ADDENDUM NO. 9

March 11, 2019

**STUDENT SUCCESS CENTER
PROJECT NO. 950512**

Photo 2

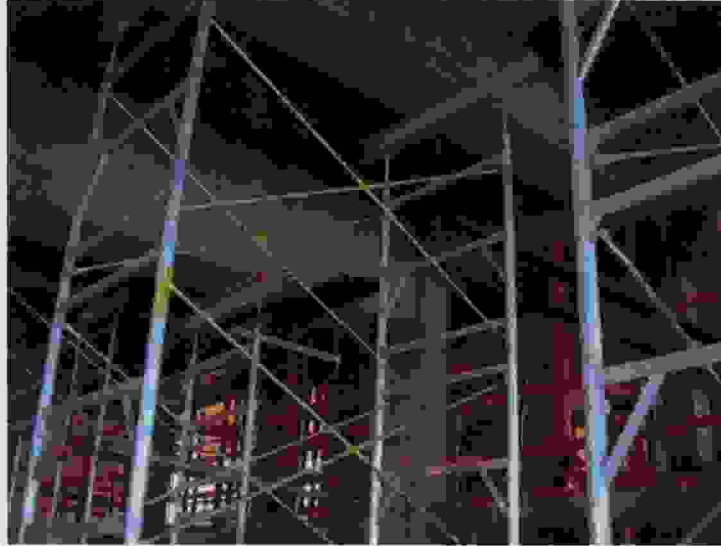
ITEM	COMMENT
North Building	1. Chilled water and heating hot water piping is stubbing through the wall at the basement level of the North Building near grid lines L and 15. The openings for these pipe penetrations do not include metal sleeves with water stop collars as shown on contract drawing M-405, detail 3. See photo 1 below. Note also that sleeves are required at all penetrations through structure per spec. section 15050, paragraph 3.5-A.

Photo 8

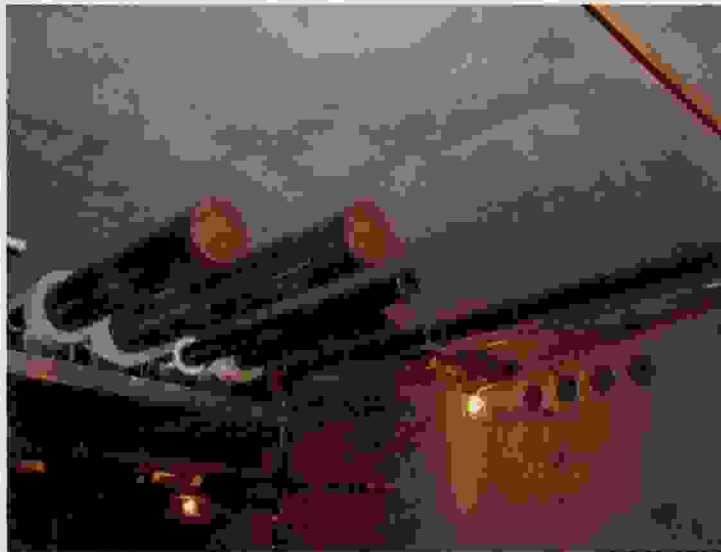
6. Steam and steam condensate lines in the basement appear to be installed level. See photo 8 below. General Note 19 on contract drawing M-002 requires all such piping to be "pitched downward in direction of flow not less than 1 inch per 40 feet."
